ALERT SERVICE BULLETIN

505-22-31

MODEL AFFECTED: 505

SUBJECT: AFT CENTER OF GRAVITY AIRSPEED
LIMITATION, INTRODUCTION OF.

Figure 1 – Aft Center of Gravity Airspeed Limitations Placard (SLS-020-600-109)

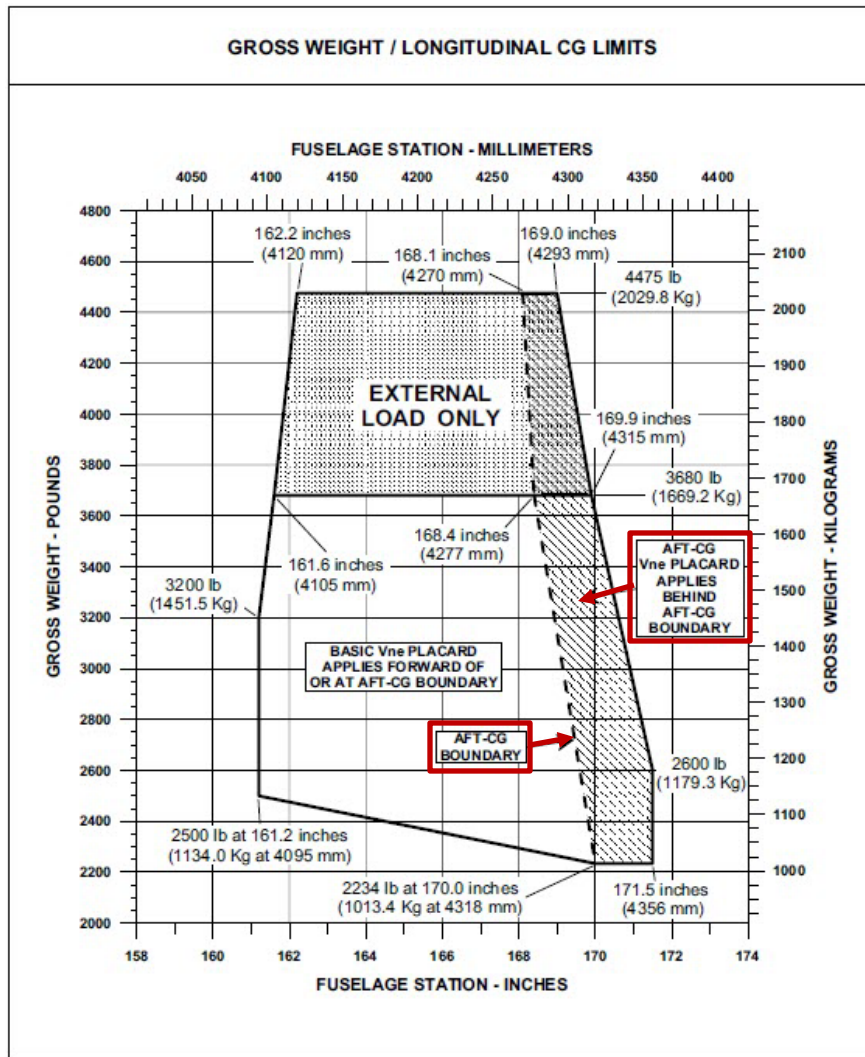
This Alert Service Bulletin is introducing new airspeed limitations when in an aft center of gravity configuration. It was found that the pilot cyclic stop window limits main rotor swashplate travel necessary for safe operation at high speeds when configured with aft center of gravity. This bulletin mandates the installation of a new, additional, Vne placard SLS-020-600-109 (Figure 1) and changes the longitudinal center of gravity limitation in Section 1, Figure 1-2, of the applicable rotorcraft flight manual (Figure 2). This new airspeed limitation will be introduced in Revision 9 of the BHT-505-FM-1 and Revision 3 of the BHT-505-FM-2 Flight Manuals and incorporated in the Garmin software 006-B2472-24.

1. Prepare the helicopter for maintenance.
2. Gain access to the right side of the cockpit (Zone 220) ([DMC-505-A-06-30-00-00A-030A-A](#)). Identify location on top of pilot's windshield at the crew headliner where placard SLS-020-600-109 (Figure 4, Detail A) is to be installed.
 - a. Thoroughly wipe the surface with a clean cloth (C-486), or equivalent, dampened with aliphatic naphtha (C-305).

- b. Install placard SLS-020-600-109 as shown (BHT-ALL-SPM, Chapter 8) (Figure 4).

Figure 2 - Gross Weight Longitudinal Center of Gravity Limits

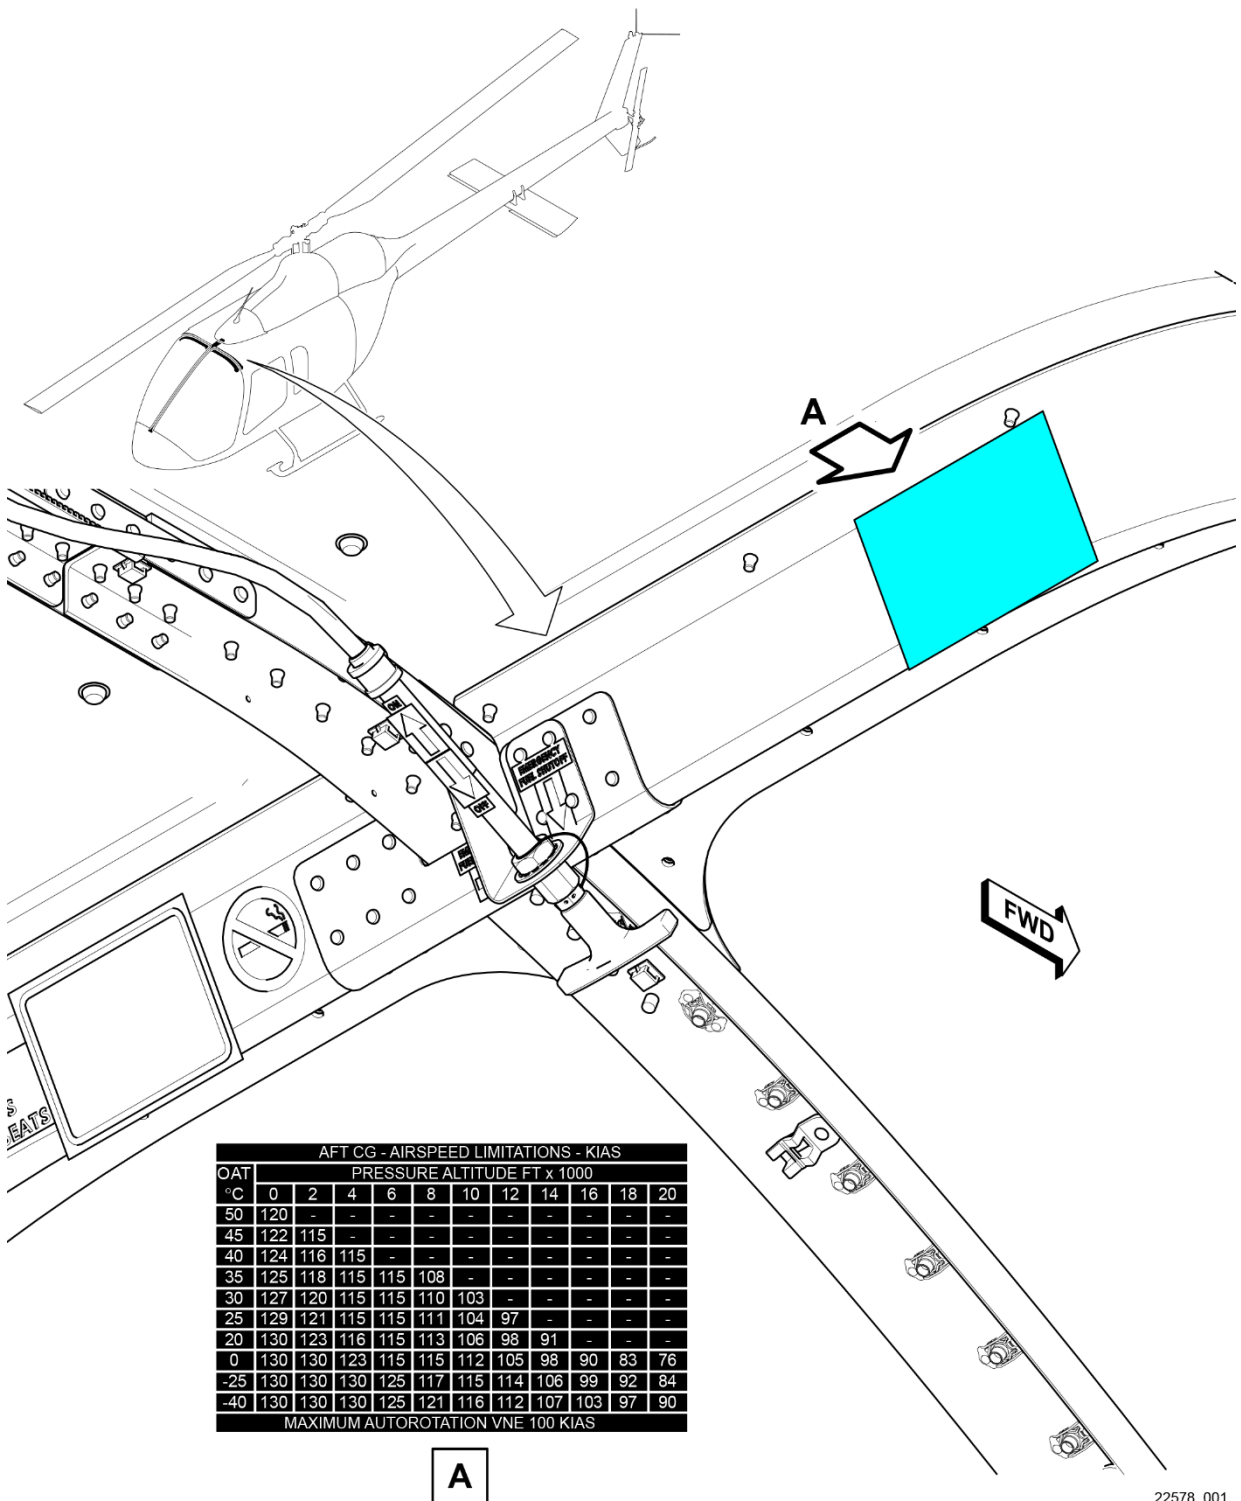
Communicate to the model 505 pilots and maintenance personnel the contents of the newly inserted Rotorcraft Flight Manual revision that includes the new longitudinal center of gravity and airspeed limitations.

Figure 5 – Printable Figure 1-2 Gross Weight Longitudinal Center of Gravity Limits (sheet 1 of 2) (Print and cut on dotted lines and insert into RFM)

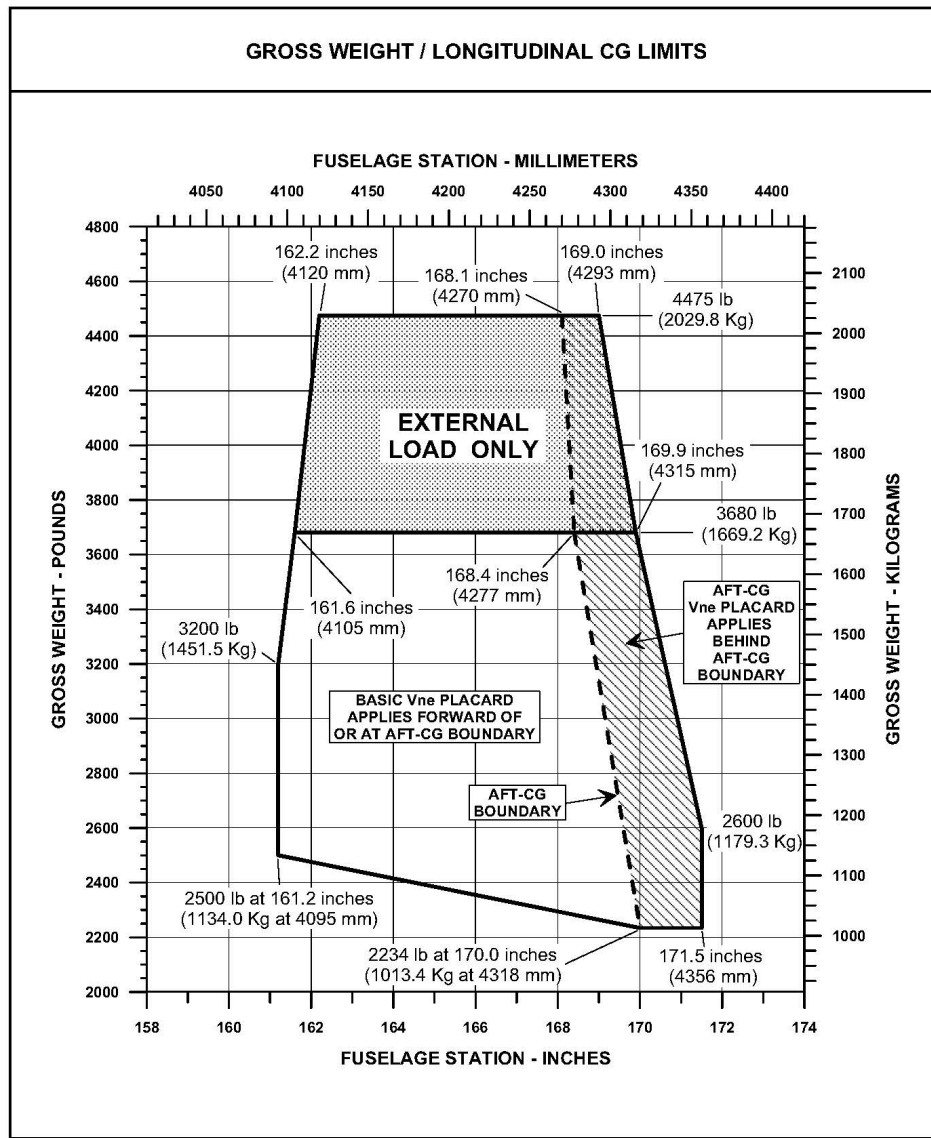
3. Verify the revision status of Figure 1-2 of Section 1, Limitations, of BHT-505-FM-1 or BHT-505-FM-2 RFM, as applicable.
 - a. For serial numbers 65011 through 65169 and 65171 through 65300 do the following:
 - (1) If Figure 1-2 of BHT-505-FM-1 **is** Revision 9 dated 20 JULY 2022 (Figure 5, sheet 1 of 2), go to step 4.
 - (2) If Figure 1-2 of BHT-505-FM-1 **is not** Revision 9, remove Figure 1-2 from the RFM and insert Revision 9 of the Figure 1-2 into the RFM, then go to step 4.
 - b. For serial numbers 65170, 65301 through 65426, and 65428 through 65436 do the following:

Figure 5 – Printable Figure 1-2 Gross Weight Longitudinal Center of Gravity Limits (sheet 2 of 2) (Print and cut on dotted lines and insert into RFM)

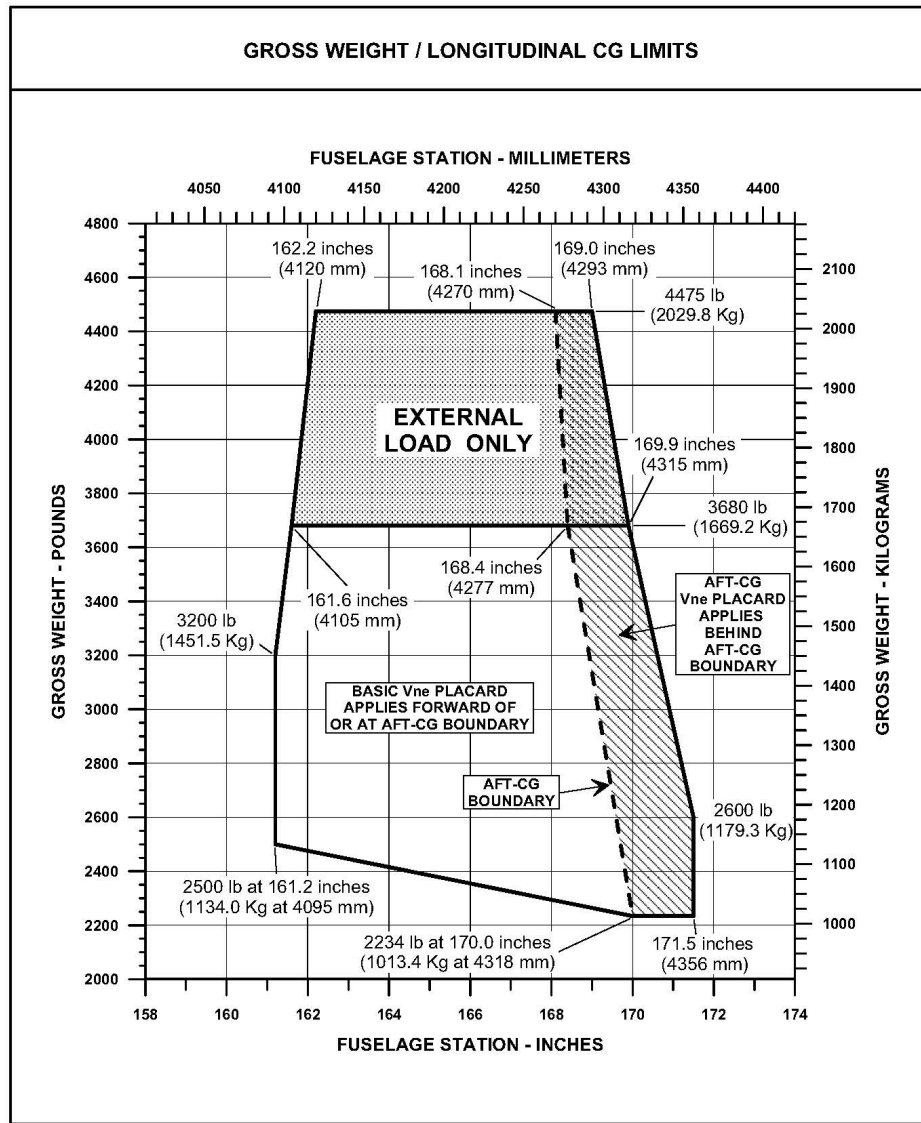
- (1) If Figure 1-2 of BHT-505-FM-2 **is** Revision 3 dated 20 JULY 2022 (Figure 5, sheet 2 of 2), go to step 4.
 - (2) If Figure 1-2 of BHT-505-FM-2 **is not** Revision 3, remove Figure 1-2 from the RFM and insert Revision 3 of the Figure 1-2 into the RFM, then go to step 4.
- c. For owner/operator convenience, a printable version of Figure 1-2 Revision 3 and Revision 9, as applicable, in the correct RFM size and format, is available in this bulletin (Figure 5).
4. Make an entry in the helicopter logbook and historical service records indicating compliance with this Alert Service Bulletin.
